Boyne Greenway

Drogheda to Mornington

Request for Further Information

TECHNICAL NOTE 170029/005

Figure 1: Route Alignment drawing – Notes & Legend

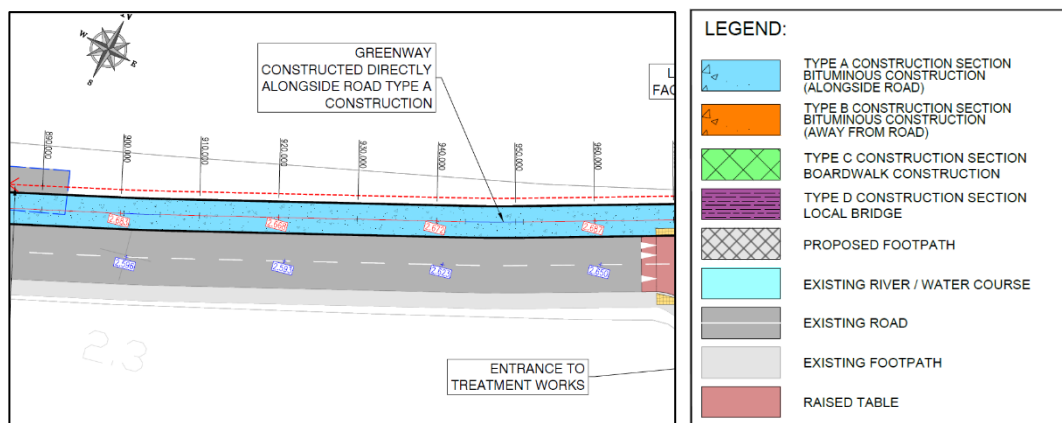
"Clarification as to the overall length of the route (there is some confusion in the documents submitted) and as to how much of the route is to be constructed directly alongside the Regional Road, and off-road (including the boardwalk area)."

4.1.11 The Route Alignment drawings (170029-2200 to 170029-2240), issued as part of the planning package, illustrates where the greenway is adjacent or away from the Regional Road, along with notes and colour coded hatching of the greenway route (see Figure 1 below).

Figure 3: Average Daily Trips and Peak Season Daily Trips for routes assessed

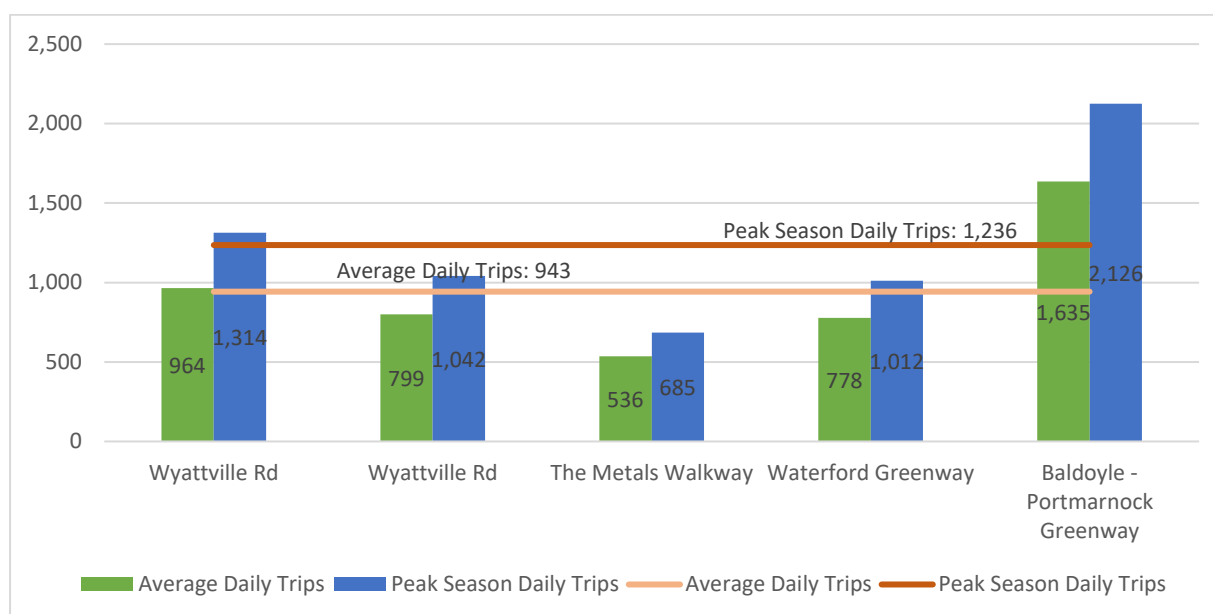
"Details should include the predicted nos. of people using the greenway per day. It should be assessed as to seasonal impact and as to whether the proposed width of the Greenway (4m) is adequate to cope with the number using the route."

5.1.16 These figures are illustrated in **Figure 3**.

5.1.17 Assessing the above similar schemes, it seems reasonable to expect Average Daily Trips of between 900-1,000 users a day, while in Peak Season for the Boyne Greenway, this number could go up to 1,200-1,300 users a day.
